## KEMPS CREEK ESTATE – SSD-9522 MOD 3

### Response to Request to Additional Information (2)

Table 1 Kemps Creek Estate – DPE Comments and Response Table

Table 2 Kemps Creek Estate – PCC Comments and Response Table

01 SECTION D-D  
Scale 1:200@A3 / 1:100@A1

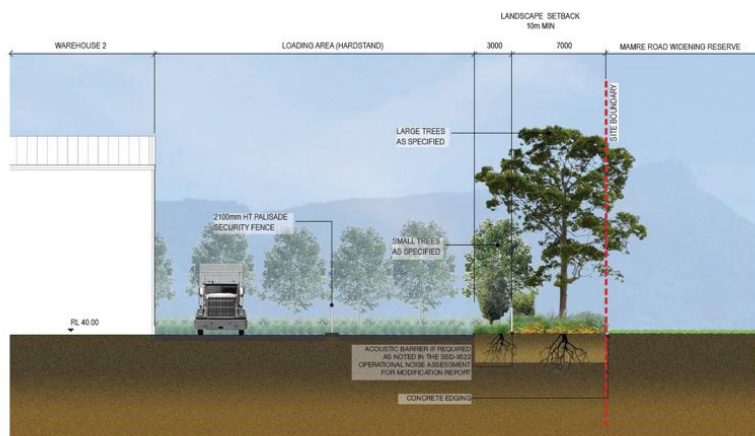
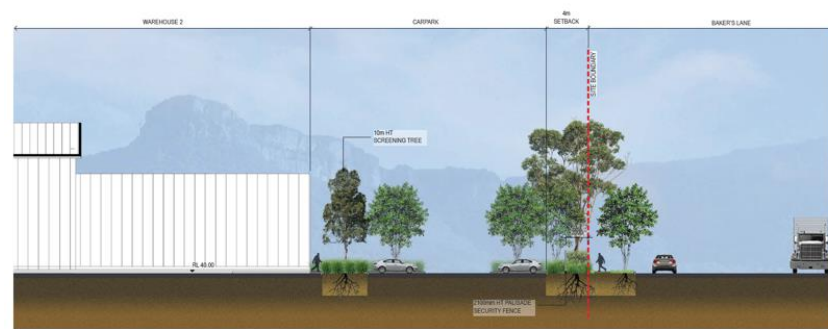
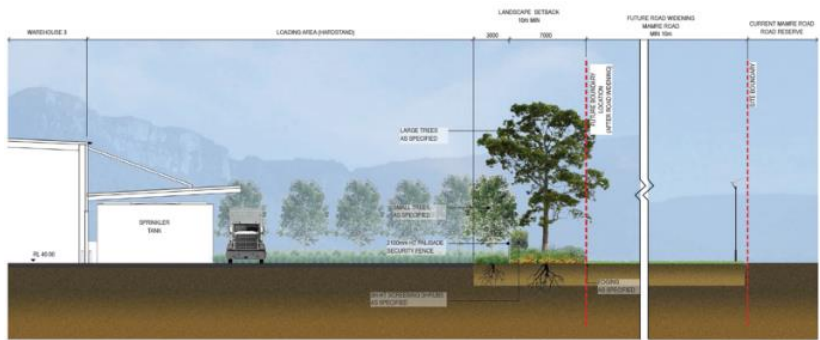
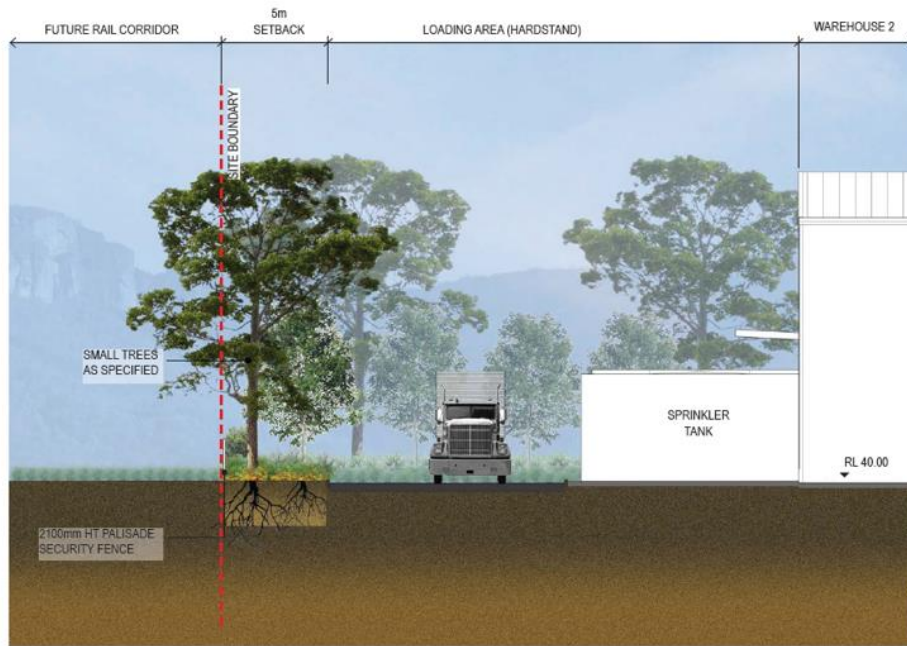
reserve, the front setback is less than 4m (refer Blister Landscape detail), a width that cannot sustain larger trees. It is not clear which species are proposed in the setback as the plant schedule is incomplete.

#### Staff breakout areas

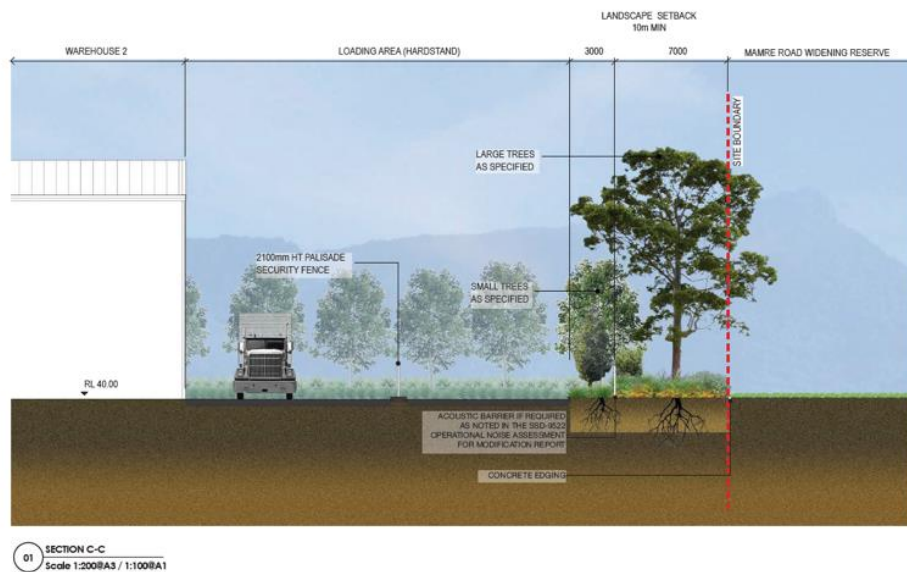
Seating should be located to provide choice to sit in shade or sun.

The objectives and controls for staff areas in the Mamre Road Precinct DCP are to be complied with.

Please refer to the typical office staff area shown on page 13 of the Landscape Plans at **Appendix E**.

<p>The use of awnings and trees within the breakout areas allows for seating in shade and is aligned to the Mamre Road Precinct DCP and the Mamre South Site Specific DCP.</p>	
<p><u>Rooftop plant</u></p> <p>Frasers comment that the visual impact of roofscape from Mamre Rd is an improvement on MOD 1 is not a suitable response. The design needs to demonstrate that the visual impact from Mamre Rd is reduced appropriately for a road of this significance.</p>	<p>The height of the building approved under MOD #1 was 26m. MOD#3 has a max height of 18m. The VIA provides a comparison between the impacts of MOD#1 and MOD#3, particularly when viewed from VP21.</p>	<p><b>Appendix B</b> in the Amended Development Report</p>
<p><u>Lot alternations</u></p> <p>Level transitions – Council’s comment should apply to the perimeter boundary with adjoining land, regardless of the use or ownership. There are insufficient cross sections and information generally to explain proposed changes in level, including retaining walls, their resulting planting conditions and visual impacts (affects VIA photomontages).</p>	<p>The level transitions and retaining wall heights within the amended MOD 3 design are consistent to what was approved in MOD 1.</p> <p>These are shown within the Civil Engineering plans and landscape drawings, providing adequate sections and information on planting.</p> <p>The VIA incorporates the level transitions between lots 1-4 and the surrounding land, showing an appropriate impact.</p>	<p><b>Appendix B</b> in the Amended Development Report</p>

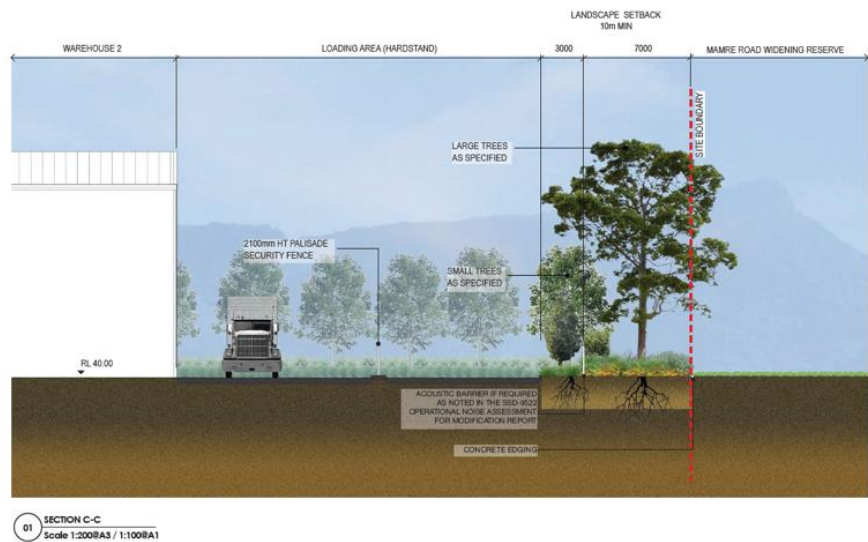
Single row of screen shrub planting is inadequate and a minimum of 3 staggered rows is recommended to ensure a dense screen. 3m height of screen plants is inadequate, recommend min. 5m height, which should physically and visually connect with the bottom of tree canopies.

VP21 confirms that due to the building pad being lower than Mamre Road, the Acoustic wall is not fully visible from Mamre Rd. Any remaining visual impacts will be mitigated by landscaping, refer to drawing L08 of the landscaping report. Section A-A and C-C shows the screening vegetation

Please see design note 2, dwg L06 in the Landscape Plans. This planting is compliant with the Mamre South Site-Specific DCP.

**2. MAMRE RD SETBACK**

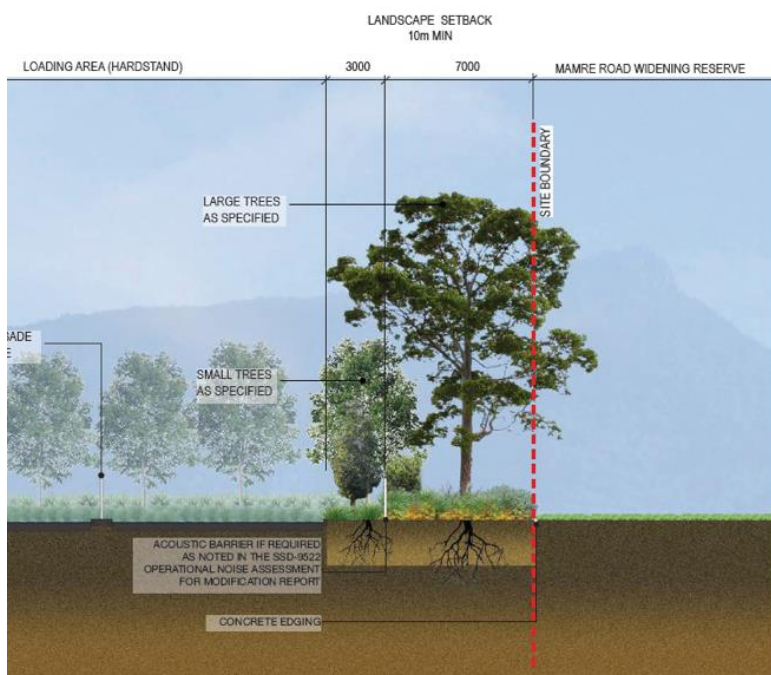
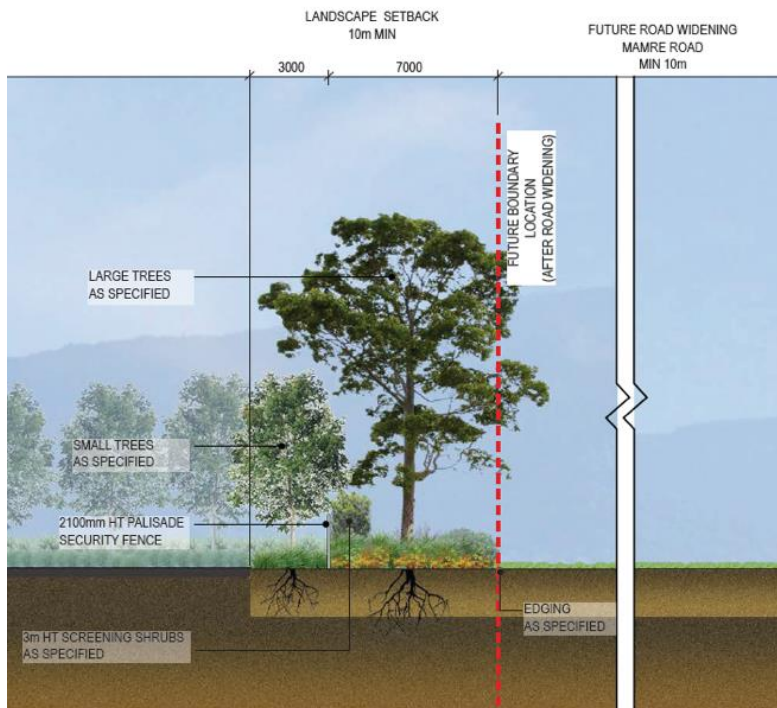
Within the 7m zone of the setback, min. 2 staggered rows of large trees is recommended to increase canopy area.

The Landscape Plan consists of layers of trees and shrubs at different heights. There is no space for 2 rows of large trees. The tree canopies will conflict with each other and potentially cause long term damage to tree health.

Importantly the amended MOD 3 design is compliant with the Mamre South Site Specific DCP
